Stone Brook Academy
(previously known as Prestmore Academy)
Site Selection Log

SITE 1
12/30/2016

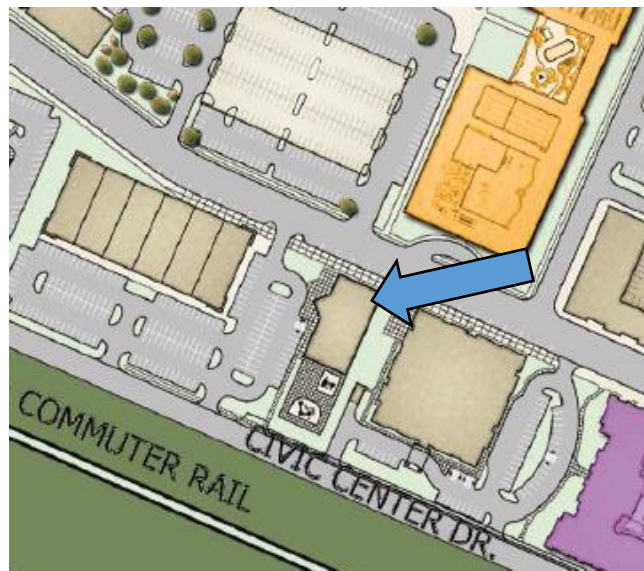
- Water/ sewer service have been pre-determined, ahead of development, for the larger 5-acre site. Stubs have been placed in the proposed Yolite row/ intersection, on Sunwood Drive; and stubs have been placed about midway within the remaining portion of the site.

- i. The location of these stubs would allow for services to be provided to the proposed Stone Brook site, and the two remnant lots. In summary, the pre-determined location of stubs is not a barrier to this proposed Stone Brook site location.

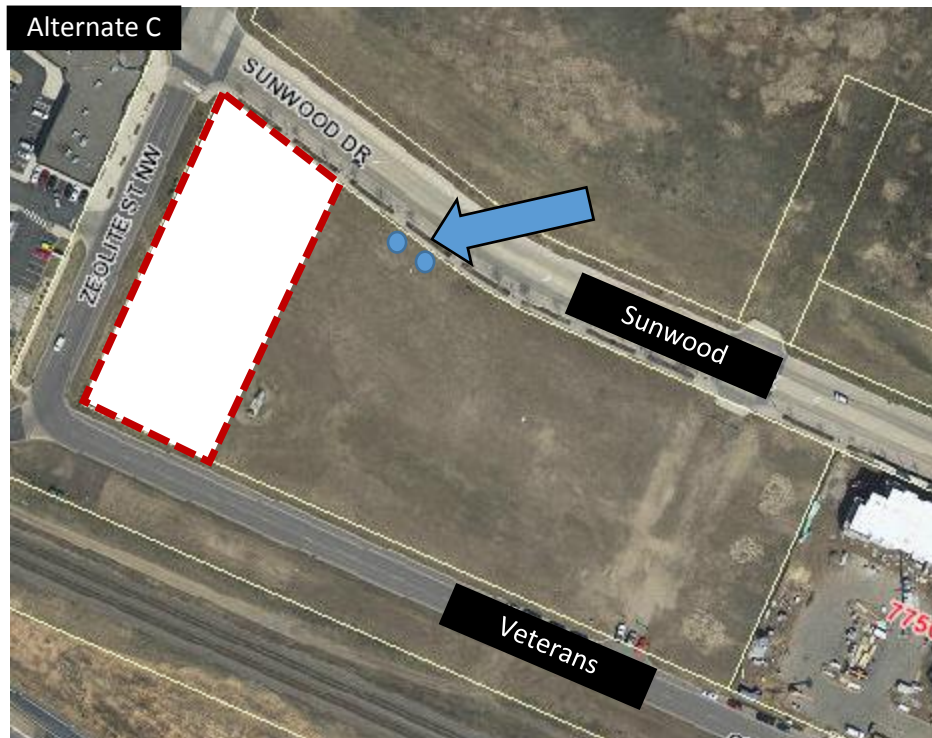
- Alternate A is physically too narrow, and too small to allow for what Stone Brook wants to accomplish (10,000 sf building plus a 1,500 sf playground). This was determined by their developer/ architect.
- Additionally, Stone Brook wants the focal point/ front of their building to be pressed up against Sunwood Drive (to be prominent). This layout would physically force the focal point of their building to be located central to the site (and the side of their building to be pressed against Sunwood). They feel this doesn't meet the "theme" of The COR.
- Lastly, Stone Brook needs a round-about drop-off at their entrance—which requires a min 100' of site width (this remnant lot site is roughly 85' wide). Ideally, they want to have at least a 185' wide site.

- Alternate B rendered identical comments from Stone Brook (compared to Alternate A).
- Although they are able to pick up additional land to the south, the shape/ constraints of the lot still make it undesirable (as they want to front Sunwood with their building, on the north). The shape of this lot creates issues with their desired site layout.

- Alternate C works for Stone Brook. They understand the public well issue, and are willing to work around. This is not their #1 option—but would be willing to consider.

- Unfortunately, water/sewer stubs are located central to this site. Therefore, staff is concerned about how this user will access water/ sewer. One option is to punch into Sunwood Drive for new stubs (not recommended by staff). Another option is to run utilities internal to the property (also not recommended by staff).

- RE the water/ sewer stubs--the easy/ desired route would be to require this lot to be taken down all at once, or at least require the Stone Brook lot to extend all the way out to the utility stubs. In that scenario, Stone Brook would be picking up nearly 2x the land they need (which they would oppose—as would staff recommend against).

- Staff would also like to note, this user may “fit” better on the east side of this site (the 5-acre Outlot B). The western portion of this 5-acre site may be better suited for retail (as it’s located adjacent to retail). An academy/ daycare makes for a good transition (between residential/ retail).
